Subject: AP1000 Response to Requests for Additional Information (TR 54)

Westinghouse is submitting a revised response to the NRC requests for additional information (RAIs) on AP1000 Standard Combined License Technical Report (TR) 54, APP-GW-GLR-033, "Spent Fuel Storage Rack Structure/Seismic Analysis." This RAI response is submitted in support of the AP1000 Design Certification Amendment Application (Docket No. 52-006). The information included in the response is generic and is expected to apply to all COL applications referencing the AP1000 Design Certification and the AP1000 Design Certification Amendment Application.

Response to Requests for Additional Information on Technical Report 54

RAI Response Number: RAI-TR54-015
Revision: 2

Figure 9.1-2 (Sheet 1 of 2) Region 1 Spent Fuel Storage Rack Layout

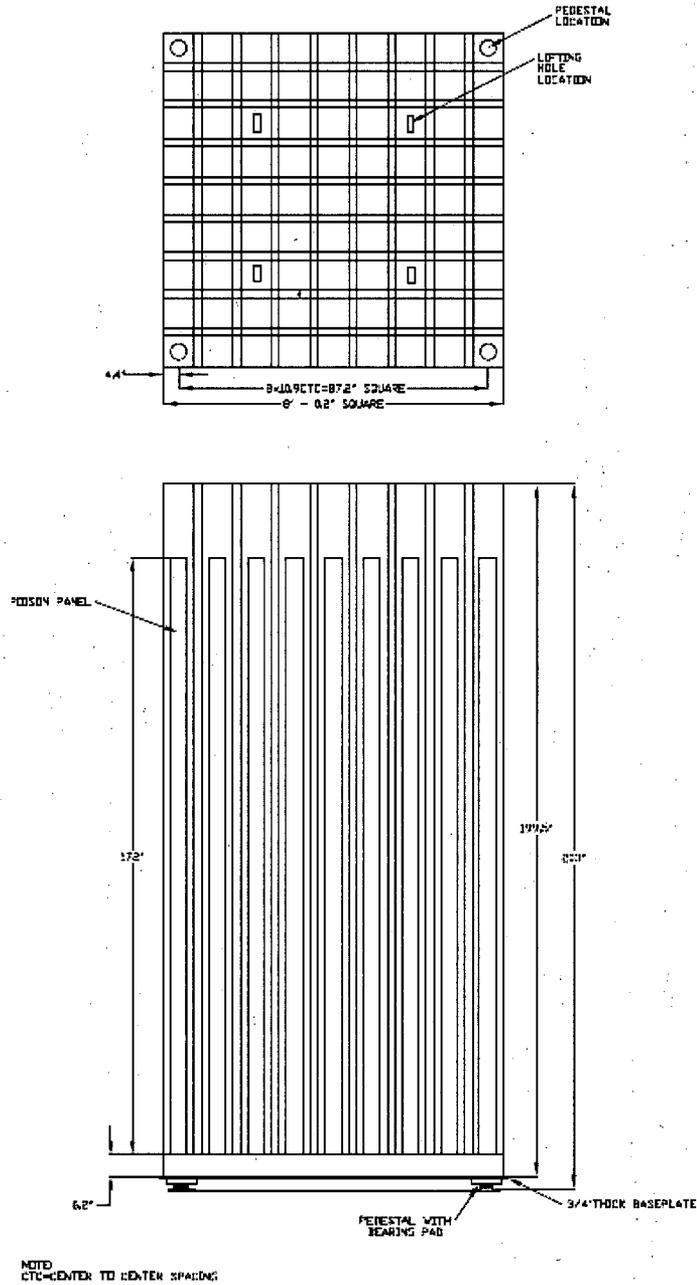
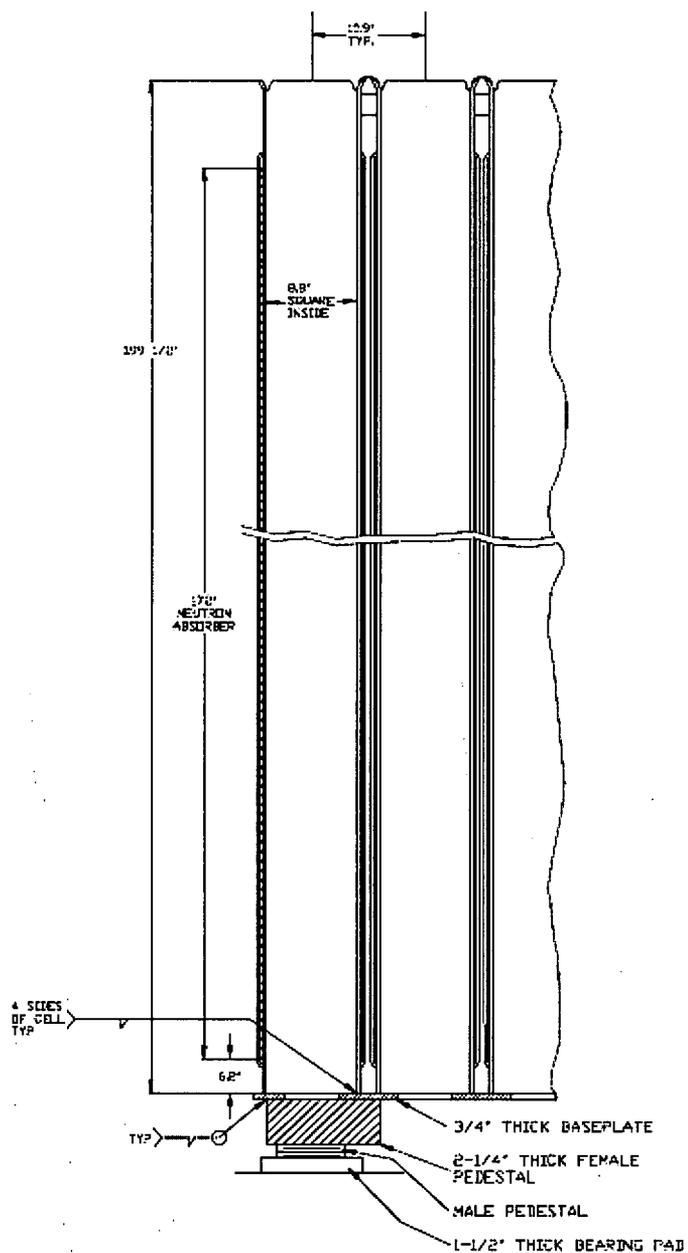
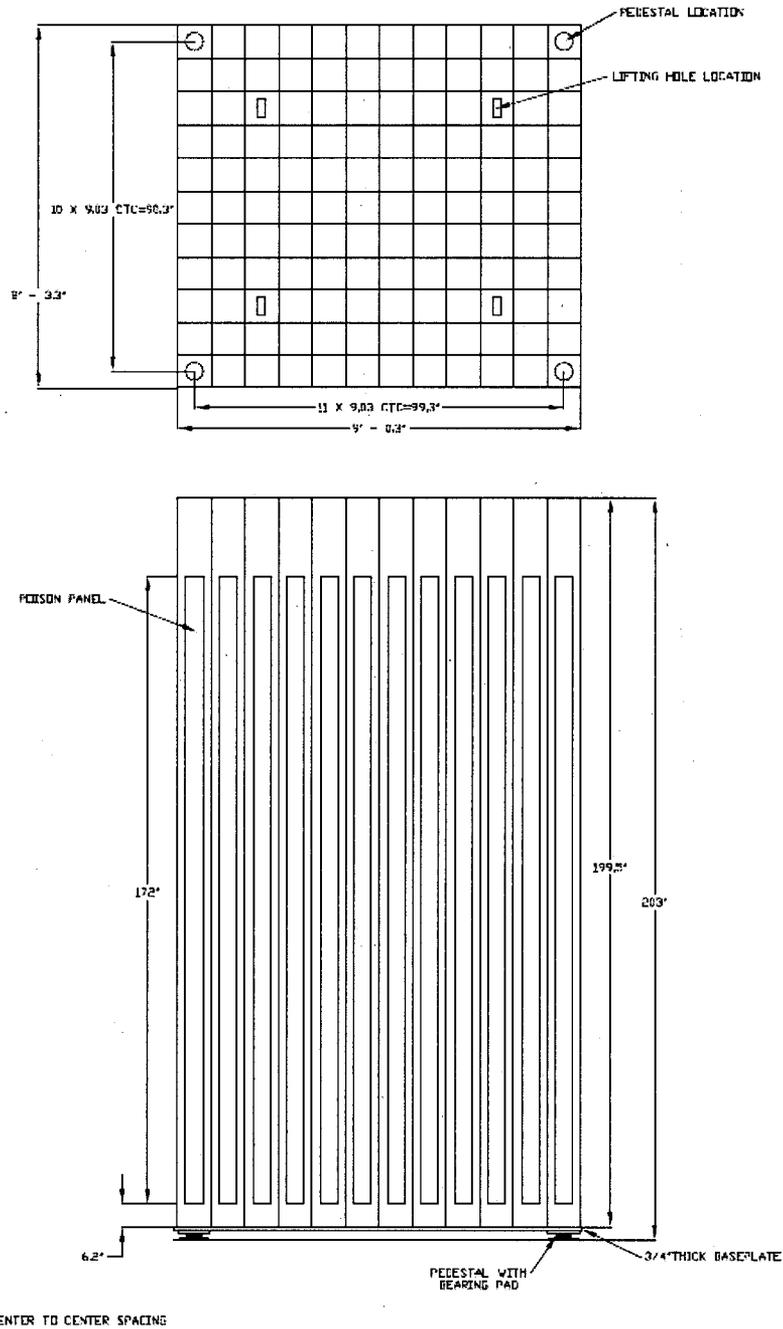
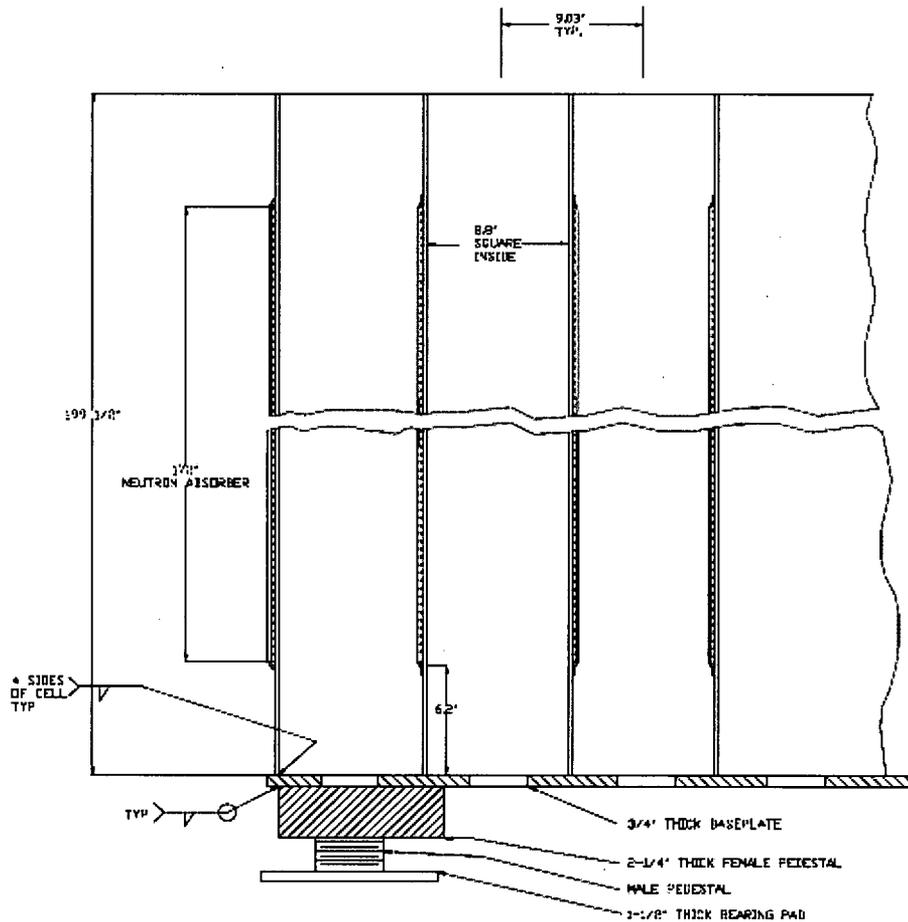
- (1) The key dimensions of the male and female pedestal components and bearing plates should be shown in the figures provided in the RAI response.
- (2) The welds connecting the pedestals to the baseplate and the baseplate to the fuel cell walls are not shown. The information for the welds should indicate the type of the weld (e.g., fillet) and whether they are all around or the extent of the welds.

- (3) Figure TR54-15.6 (in the RAI response) does not show any leak chase channels in the spent fuel pool floor. W indicated that there are leak chase channels; however they are not shown in rack layout figure. W confirmed that the fuel rack analyses did not consider the possible impact loading of a rack pedestal over the leak chase channel. Therefore, the staff request W to explain why the effects of the leak chase channel were not considered in the fuel rack analyses and the calculation that demonstrates the adequacy of the liner/concrete in the local region around the pedestal which is part of the TR report. Also, Figure TR54-15.6 which will be included in the TR should be revised to show the leak chase channels if they are used.

Westinghouse has revised the layout figures for Region 1 and Region 2 spent fuel racks as requested. These figures are presented below in the DCD Revision and TR Revision sections below. Leak chases are used in the spent fuel pool. The plates making up the spent fuel pool liner have been designed such that no rack pedestals are over leak chases.

The spent fuel rack figures in section 9.1 of DCD revision 16 are replaced with the following figures:

Figure 9.1-4 Spent Fuel Storage Pool Layout (889 Storage Locations)

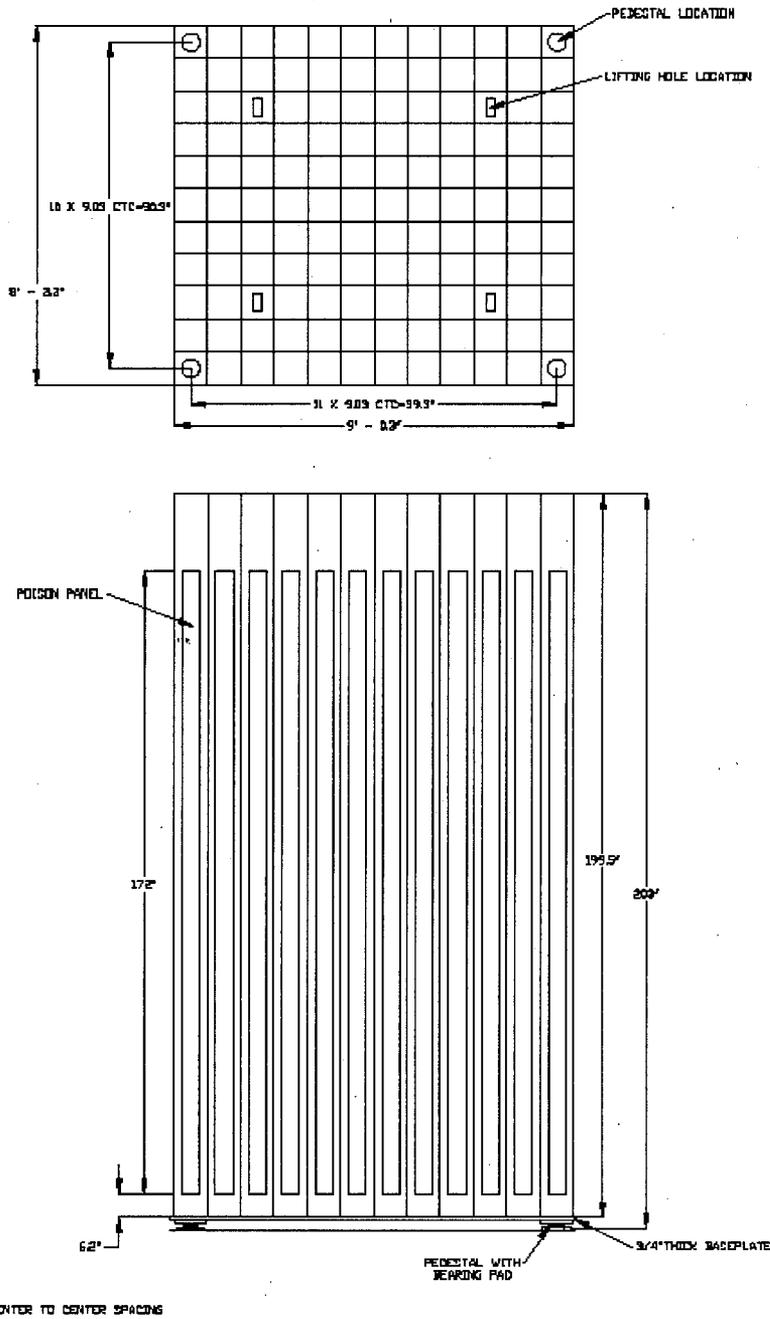
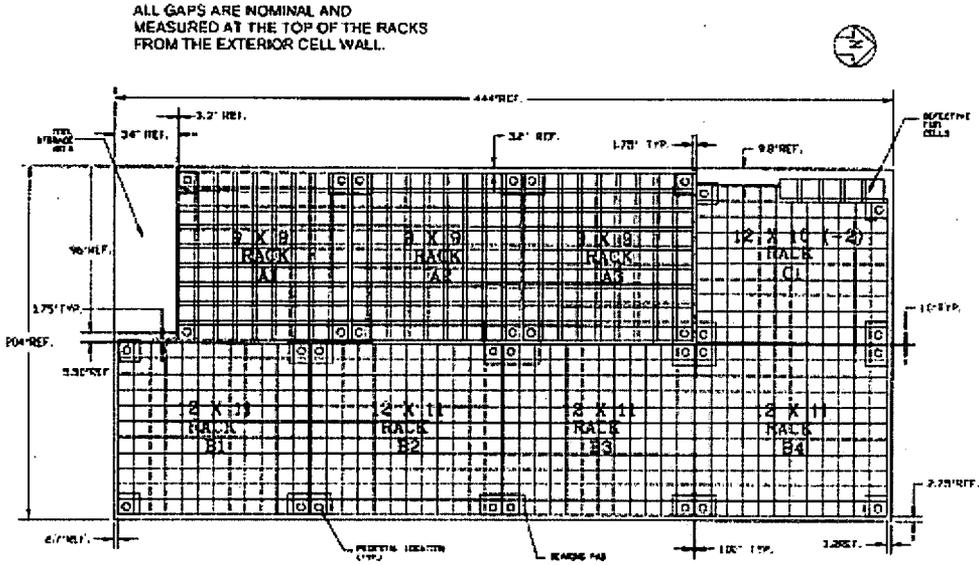
Westinghouse agreed to change spent fuel pool rack layout shown in Figure 2-1 of TR-54 Rev 2 and DCD Figure 9.1-4 to change note to All gaps are nominal and measured at the top of the rack from the exterior cell wall. Also from RAI-TR54-36 Rev 2 response, the tool area is shown to be 34 inches rather than 36 inches. In addition, Figure 2-3 and DCD Figure 9.1-3 (sheet 1 of 2) have been changed to correctly reflect the distance from the TOP of the bearing pad (not the bottom of the bearing pad) to the top of the rack.

Replace Figures 9.1-3 (Sheet 1 of 2) and 9.1-4 with the following

Fig 6.1 Configuration

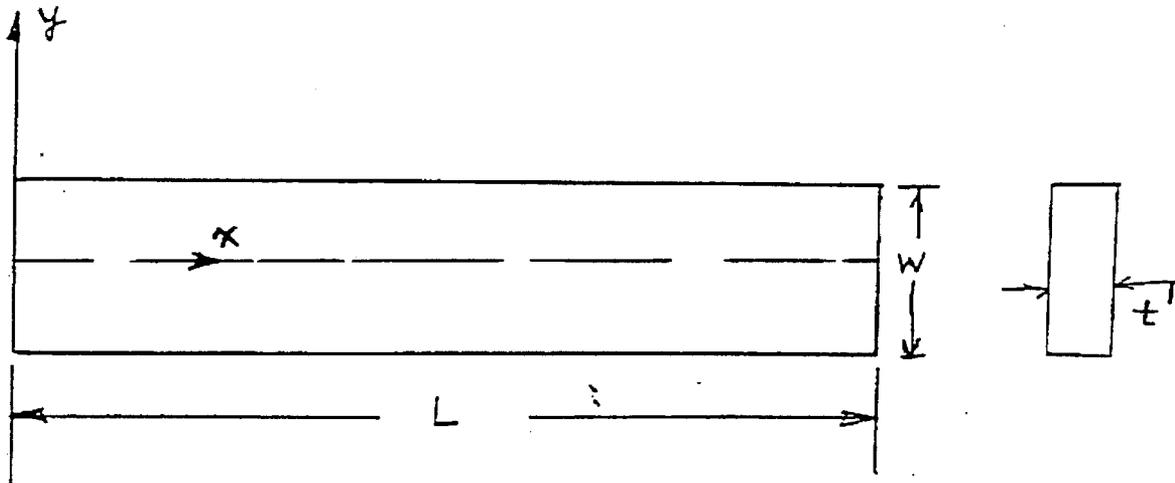
- (ii) regarding the last quoted sentence above, SRP 3.8.4, App. D indicates that thermal loads due to temperature effects and temperature gradients across the rack structure need to be considered. Temperature gradients can occur due to differential heating effects between one or more filled cell(s) and one or more adjacent empty cell(s). The stresses from these types of thermal loads should be considered because they can still lead to localized failure of the structure. When responding to this, consider temperature loads due to normal and accident conditions, as noted in your Table 9.1-1 and SRP 3.8.4, App. D.

(2) The 0.931 term used in the denominator of the shear stress equation is equal to the following quantity:

This constant term results from the derivation of the shear stress equation, which is given below.

Figure 9.1-4

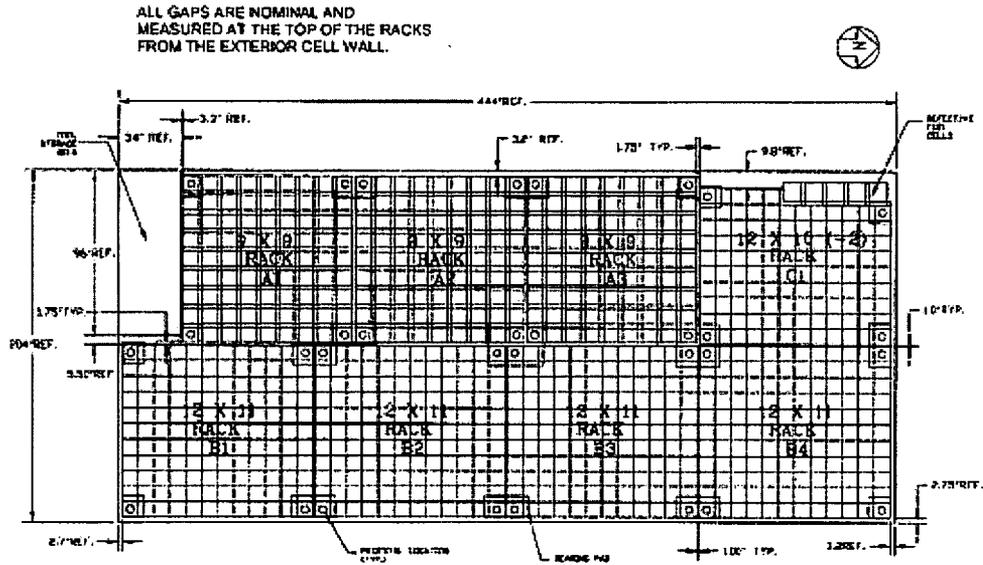
Westinghouse was requested and has agreed to revise Figures TR-54 Rev. 2 Figure 2-1 and DCD Figure 9.1-4 Spent Fuel Pool Layout to show rack-to-rack and rack-to-wall gaps, note where the gaps are measured and to indicate the smaller tool storage area. These are shown in the DCD and TR Revisions sections. These same changes were also implemented in RAI-TR54-36 Rev.1.

Revise Figure 9.1-4 as follows:
